GFA AIRWORTHINESS DIRECTIVE

TYPE AFFECTED: H-303 Mosquito and Mosquito B;
304 (not 304 B or 304 CZ).

SUBJECT: Rudder gimbal drive, rear actuator arm.

**Airworthiness
Directive
2003-005**

203-15-10-2

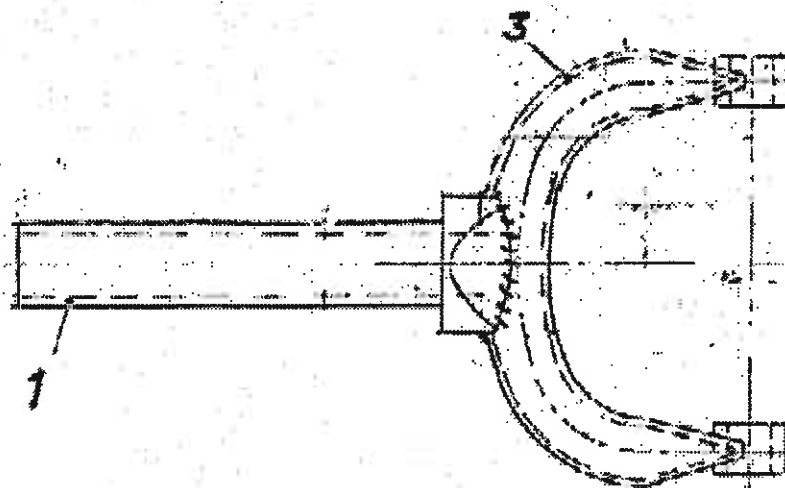
ACTION REQUIRED: Replace actuator arm with improved item.

Exchange of an improved actuator arm.

1 off rudder actuator arm made according to drawing 203-45-10-2
1 off M4 stop nut
3 off Split pins, 1.5 x 16 mm

Only genuine parts made in accordance with drawing No. 203-45-10-2 must be used.
